# Access Compliance Report

## Public Rights-of-Way

### (Curb Ramps)

Intersection ID: 3159	Main Street: DAUPHINE_DR	Cross Street: MAGENNIS_GROVE_CT	Location: S
ADA ID: A4A0C85DD47D	Ramp Type: Perp	Initial Pass/Fail: Fail	Overall Compliance: No
Severity Score: 37.5			
Codes/Mitigation Info/Possible Solution		Field Measurements/Component Compliance

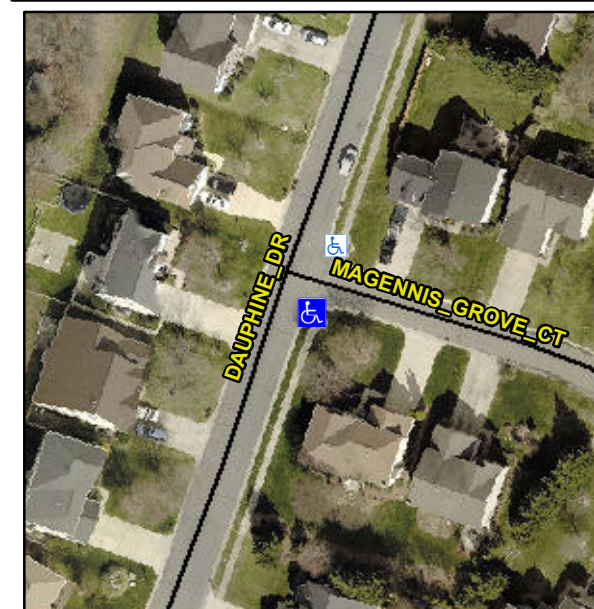
**R304.2.2, R304.5.3**

Compliance	Description	Data	Compliance	Description	Data
N/A	Ramp Length (in)	51.0	No	Ramp Slope (%)	9.5
Yes	Ramp Width (in)	48.0	No	Ramp XSlope (%)	8.7
N/A	Flare Type LT	N/A	N/A	Flare Type RT	N/A
N/A	Flare Slope LT (%)	N/A	N/A	Flare Slope RT (%)	N/A
N/A	Flare Traversable LT?	N/A	N/A	Flare Traversable RT?	N/A
N/A	Landing Length (in)	N/A	N/A	DWS Provided?	N/A
N/A	Landing Width (in)	N/A	N/A	DWS Contrast?	N/A
N/A	Landing Slope (%)	N/A	N/A	DWS Length (in)	N/A
N/A	Landing X Slope (%)	N/A	N/A	DWS Full Width?	N/A
N/A	Landing Curb? (Y/N)	N/A	N/A	DWS Offset (in)	N/A
N/A	Shared Landing?	N/A			
N/A	Gutter Ponding?	N/A	N/A	Gutter Slope (%)	N/A
N/A	Gutter Lip Ht (in)	N/A	N/A	Gutter X Slope (%)	N/A
N/A	Painted X Walk1?	No	N/A	Painted X Walk2?	N/A
	X Walk 1 Direction	To NE		X Walk 2 Direction	N/A
N/A	X Walk 1 Width (in)	N/A	N/A	X Walk 2 Width (in)	N/A
	X Walk 1 Slope (%)	4.4		X Walk 2 Slope (%)	N/A
	X Walk 1 X Slope (%)	7.1		X Walk 2 X Slope (%)	N/A

**Remove & Replace Entire Ramp.**
